Deskew in 200/400GE SM-PMAs (CI 176)

(in support of comment #368)

Comment # 368 and referenced motion

CI 176 SC 176.5.1.3.1 P201 L32 # 368

Fig 176-2 (200GBASE-R 8:1 PMA), CI176 D1.0

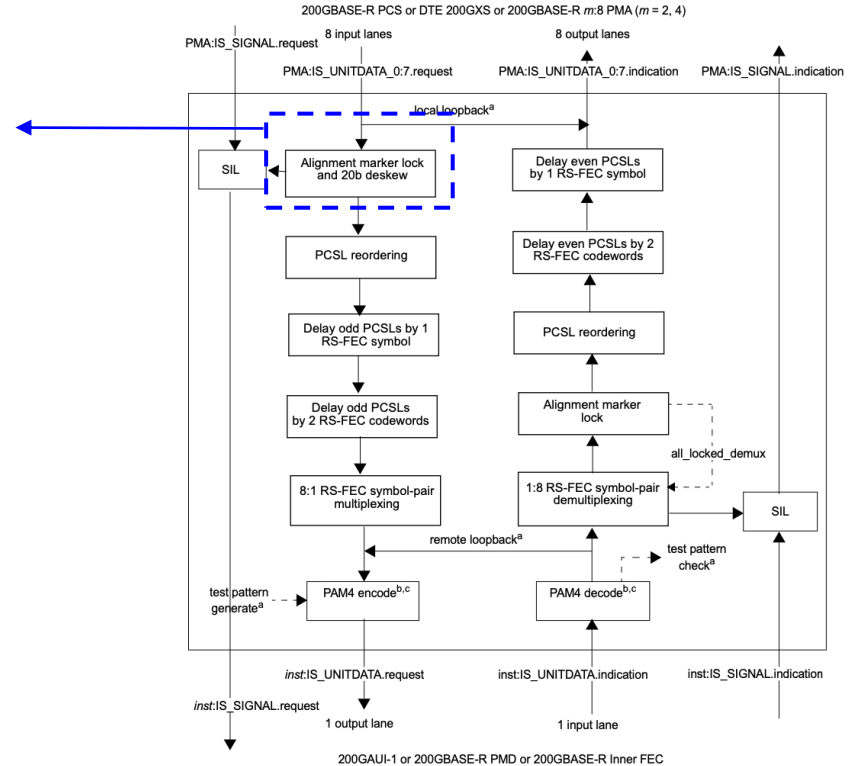
The 20b deskew in D1.0 is not sufficient to guarantee 4 CW interleaving for 200GbE/400GbE SM-PMAs

20b deskew is incorrect. According to Motion #10 in https://www.ieee802.org/3/dj/public/23_07/motions_3cwfdfj_2307.pdf, it is required to deskew to codeword boundaries.

- Motion # 10 adjustment to baseline presentation ([he 3dj 02a 2307](#)) was not implemented in D1.0
- The adjustment in the referenced motion requires deskew to codeword boundaries for 200/400GE
 - note : *100G/lane input lanes* is assumed to mean for the cases that are not n:n PMA
- Comment # 368 was submitted to correct this

Remove the second and third paragraph in 176.5.1.3.1 and reuse 119.2.5.1.

Recommendation: Specify the codeword alignment process with either Option 2 or Option 3
